SOUTHLAND ROYALTY COMPANY LLC
30-039-21107 LINDRITH UNIT #085

SRC requests approval to plug and abandon the Lindrith Unit #85.
Attached are the proposed procedure, current and proposed WBDs, Reclamation Plan, and Noxious Weed form.

Re: Permanent Abandonment
Well: Lindrith Unit 85

CONDITIONS OF APPROVAL

PROPOSED P&A

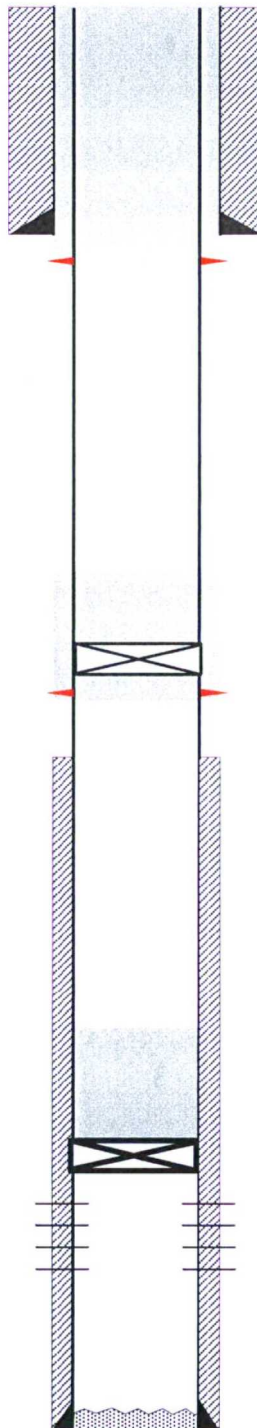
- Notify NMOCD 24hrs prior to beginning operations.
- Extend Plug #1 from 2975'-2580' to cover the Ojo Alamo top.
- Extend Plug #2 from 1450'-1175' to cover the Nacimiento top.

1. Plugging operations authorized are subject to the attached "General Requirements for Permanent Abandonment of Wells on Federal and Indian Lease."
2. Farmington Office is to be notified at least 24 hours before the plugging operations commence (505) 564-7750.
3. CBL required from CIBP @2975' to surface to confirm TOC. Submit electronic copy of the log for verification to the following addresses: jkillina@blm.gov and Brandon.Powell@state.nm.us . Based on CBL results inside/outside plugs and volumes may be adjusted accordingly.
